Updated TDD PHY Control State Diagram

November 10, 2025

Ching-Yen Lee, Realtek
Frank Wang, Realtek
Wei Lou, Broadcom

Updated TDD PHY Control State Diagram

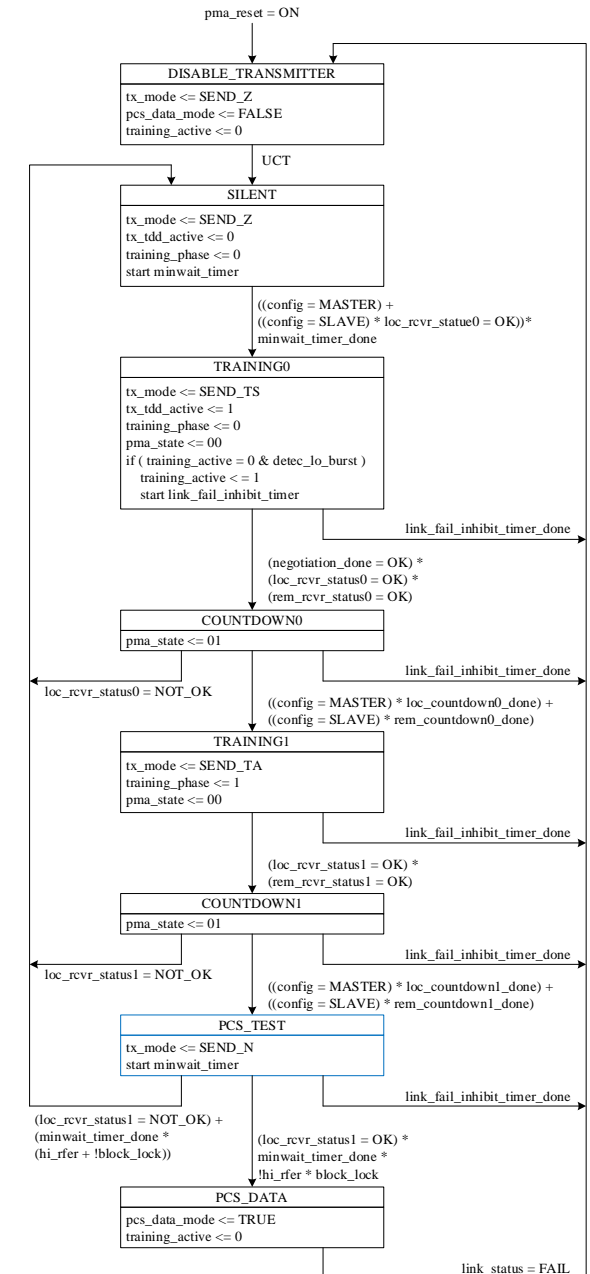
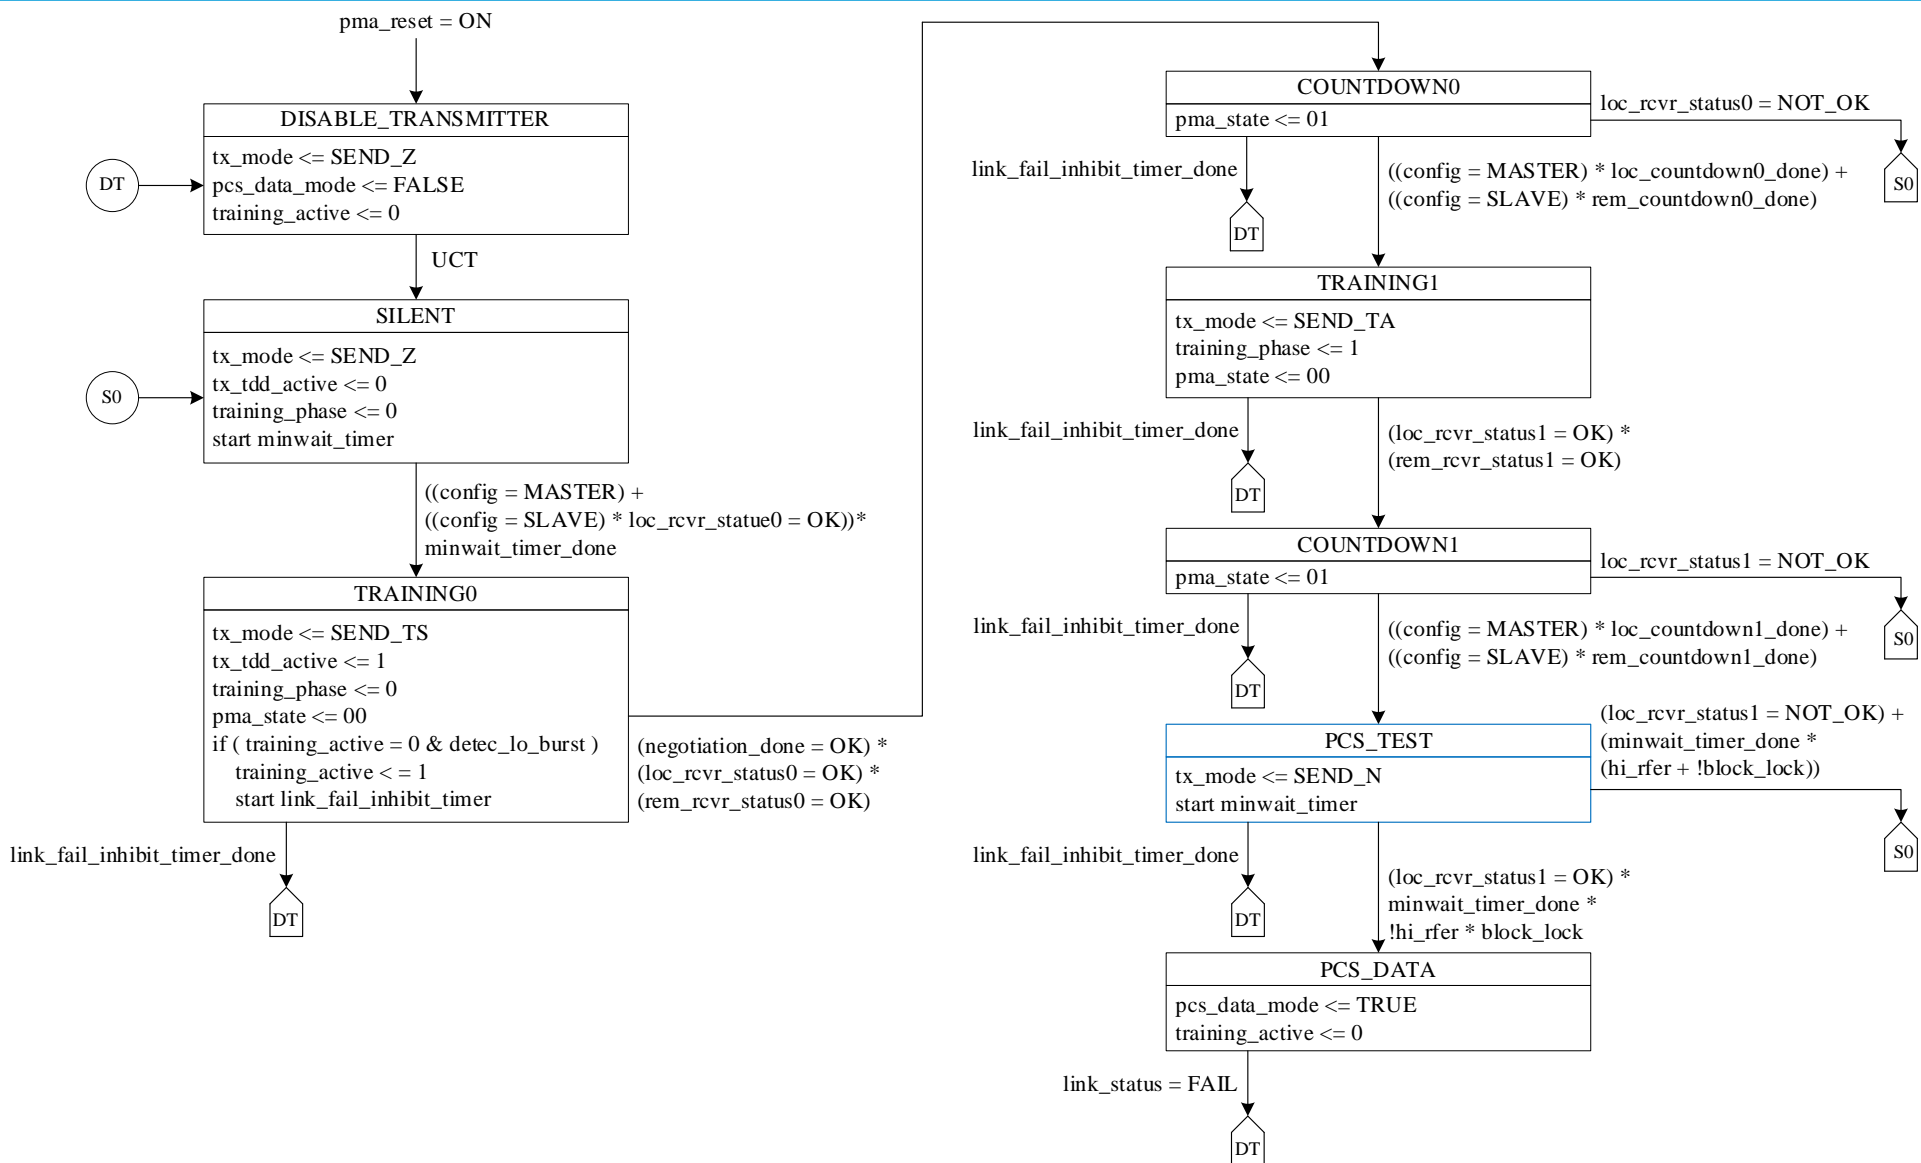
- This presentation provides update to the TDD PHY Control state diagram presented in May 2025.
 - Previous presentation: https://ieee802.org/3/dm/public/0525/Baseline_Text_TDD_051125.pdf
- The updated TDD PHY Control state diagram has the following modifications
 - SILENT1, TRAINING2, and COUNTDOWN2 are removed
 - PCS_TEST is inserted between COUNTDOWN1 and PCS_DATA

- The right figure is updated TDD PHY control state diagram, and the 8 states from top to bottom are: DISABLE_TRANSMITTER, SILENT, TRAINING0, COUNTDOWN0, TRAINING1, COUNTDOWN1, PCS_TEST, and PCS_DATA.
